NAME OF CUSTOMER: NABINAGAR POWER GENERATING CO. PVT. LIMITED (NPGC)
NAME OF PROJECT : 400/132 KV SWITCHYARD PACKAGE AT NABINAGAR SUPER THERMAL POWER PROJECT (3 X 660 MW)

400KV NABINAGAR TPP (BRBCL) EXTN - SINGLE LINE DIAGRAM

NTPC DRAWING NO. 0370-572-PVE-F-442				
CUSTOMER NABINAGAR POWER GENERATING CO. PVT. LTD. (NPGC)				
PROJECT : NABINAGR STPP (3X660 MW) 400/132kV SWITCHYARD PACKAGE				
	BHARAT HEAVY ELECTRICALS LTD. TRANSMISSION PROJECTS DIVISION NEW DELHI		DEPT CODE	NAME
			DRN	RK
			CHD	SK
		APPD	DKM/RS	
TITLE Equipment Earthing Philosophy & Details				
		DEPT.	SCALE	DRAWING NO.
		SIGN		TB-4-350-316-017
		DATE		SHEET 01 OF 22 REV. 00

EQUIPMENT EARTHING DETAILS NOTES

EQUIPMENT EARTHING DETAILS
ROD EARTH ELECTRODE WITHOUT TEST PIT

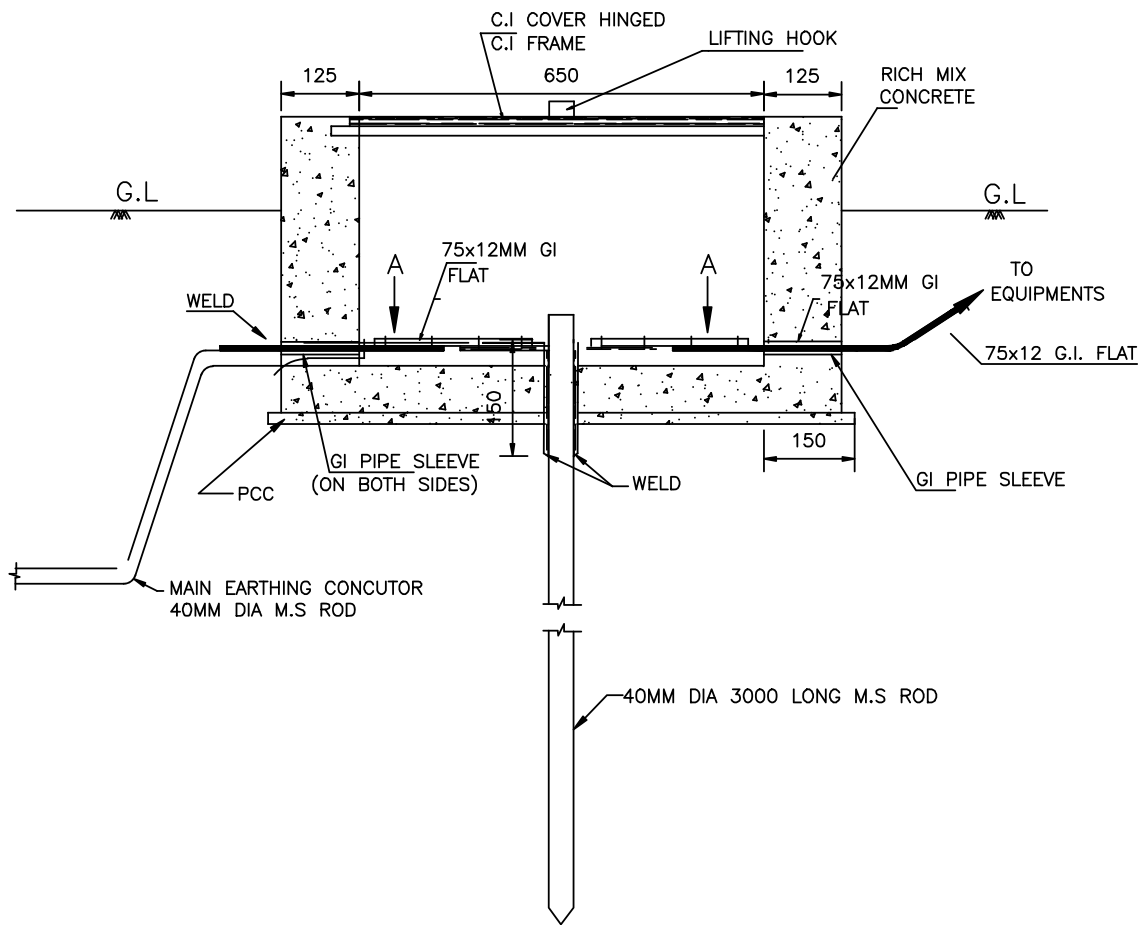
Comments as marked above

EQUIPMENT EARTHING DETAILS ROD EARTH ELECTRODE WITH TEST PIT

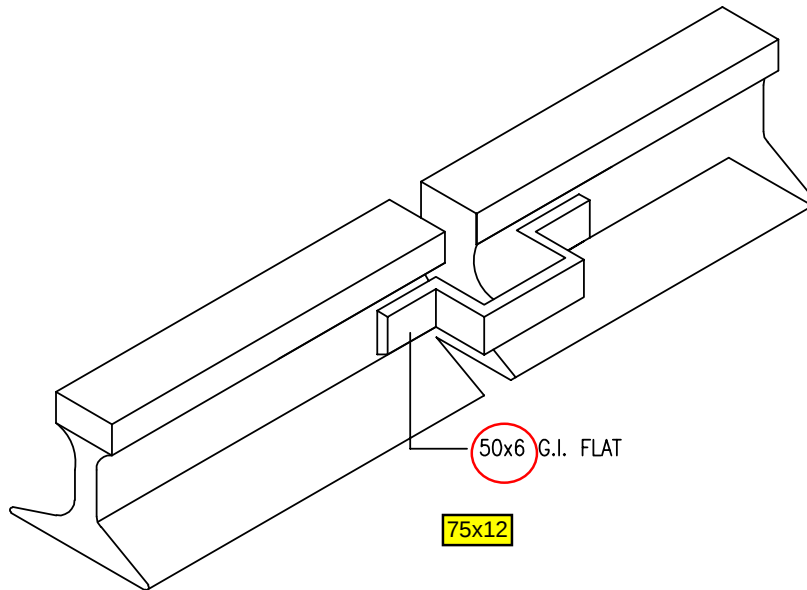
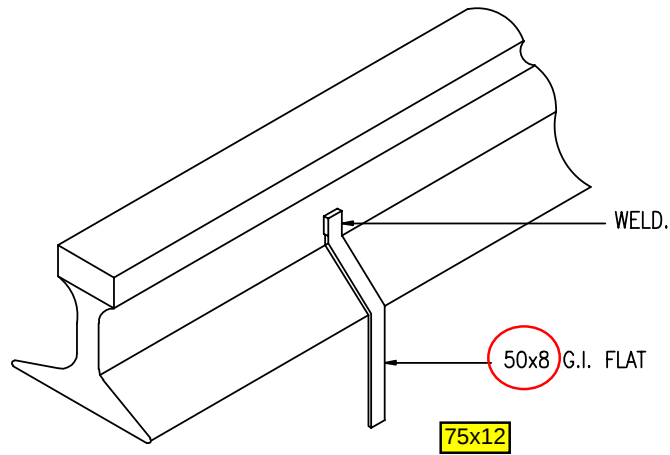
Mark dimensions

EQUIPMENT EARTHING DETAILS GATE/FENCE POST

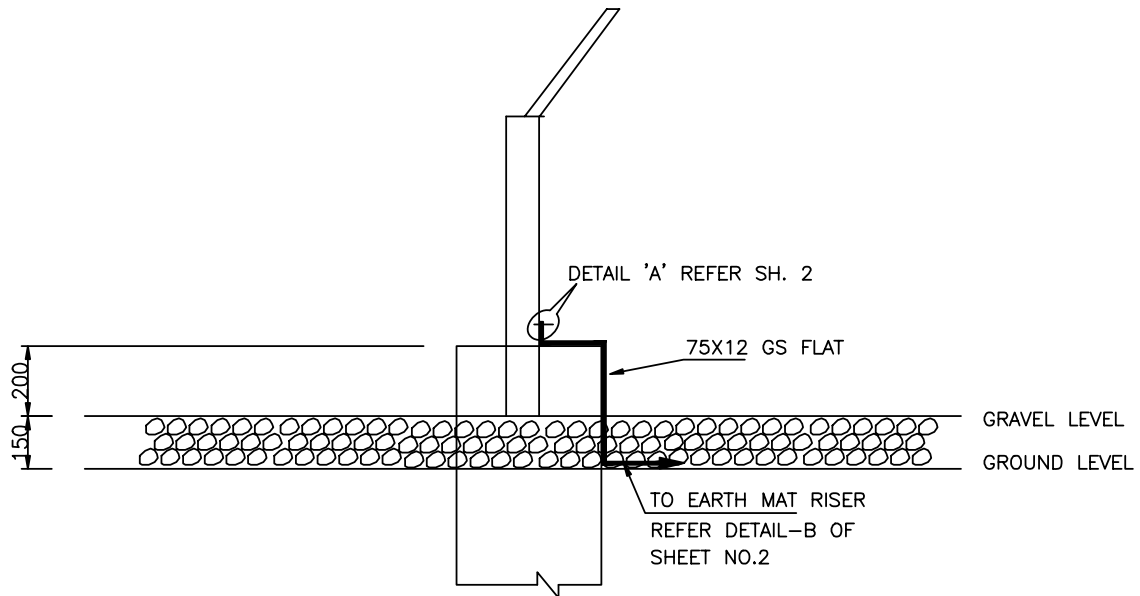
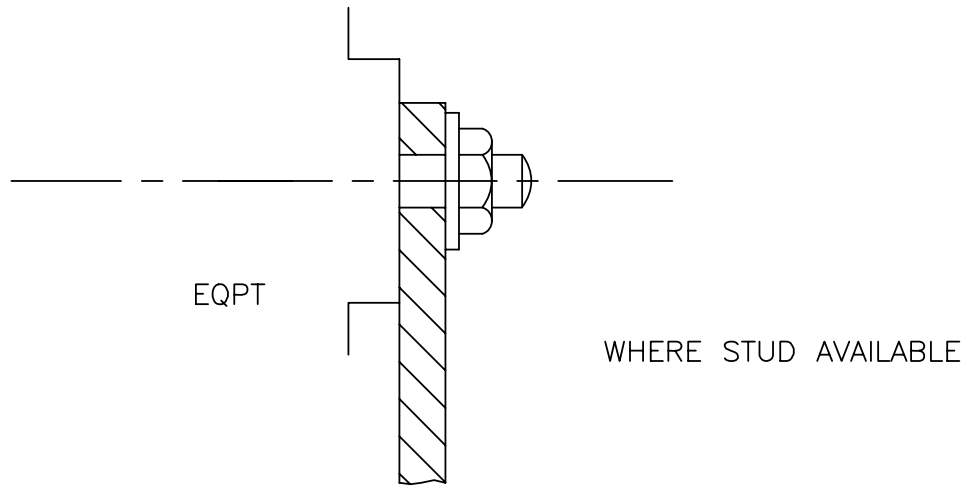
Pl refer fence and gate drawing and its earthing arrangements

DATE	ALTERED	30%.	 SCALE 1" = 150'	CPO CODE	DRAWING NO. TB-0-350-316-005	REQ.
DESIGNED	CHECKED	CODE				
DATE	APPROVED					
PREPARED BY: REVISOR: REVISED IN LINE WITH COMMENTS DTD. 12.2.14.			335V NABINGAR STRP- LAYOUT PLAN & SECTION			
TITLE						
SHEET NO.		01	NEXT SHEET		02

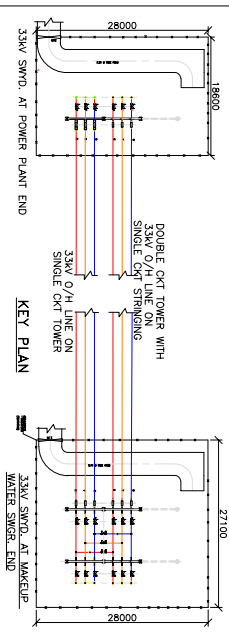
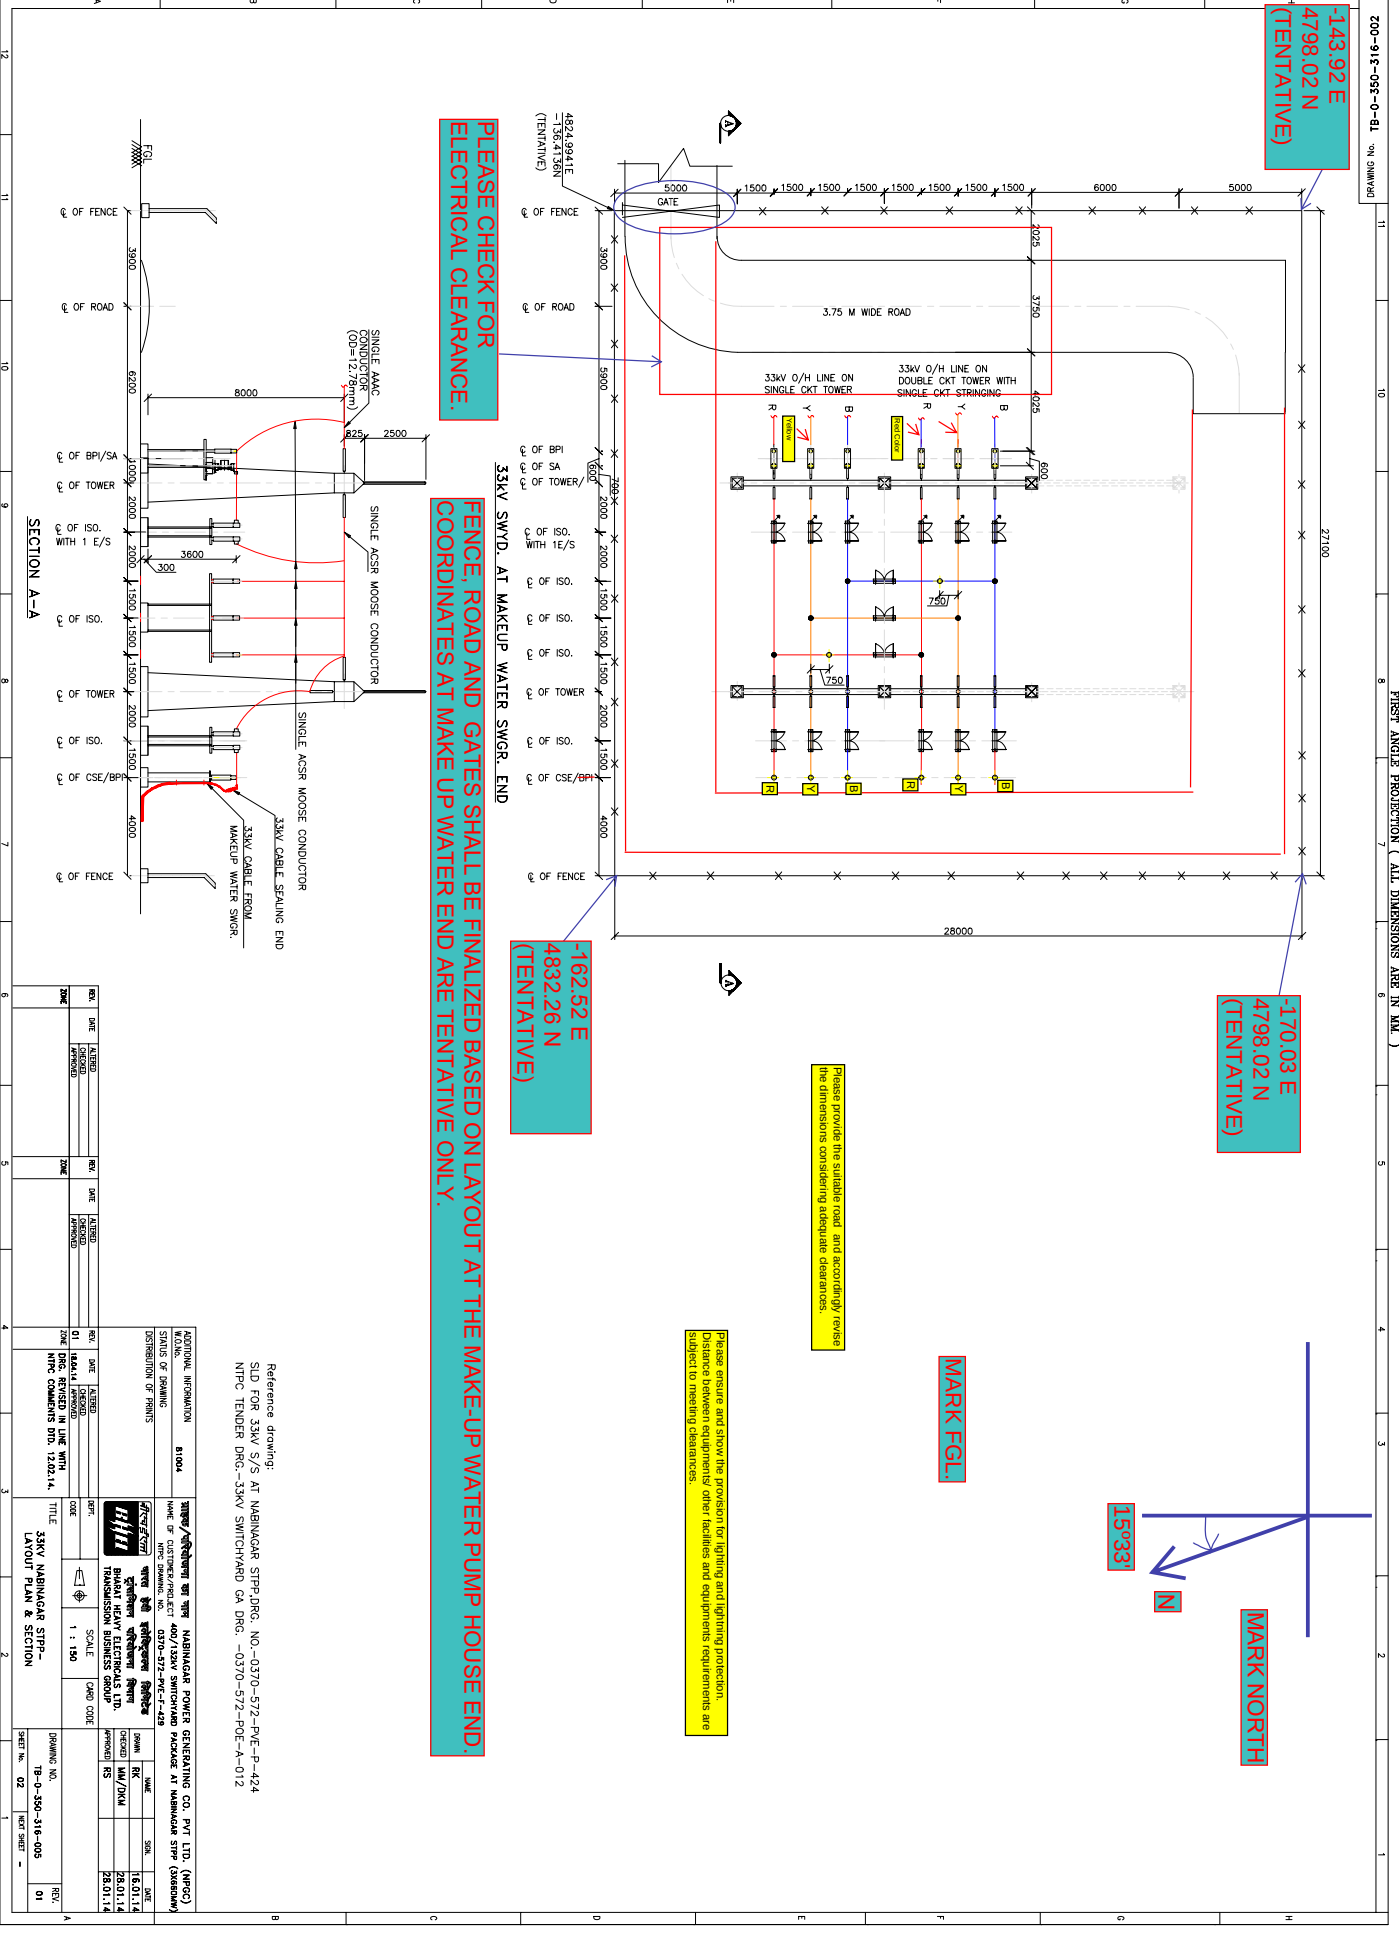
MARK FGL.

SHOW KEY PLAN AT PLANT END. SHOW THE LOCATION WITH RESPECT TO SWITCHYARD.
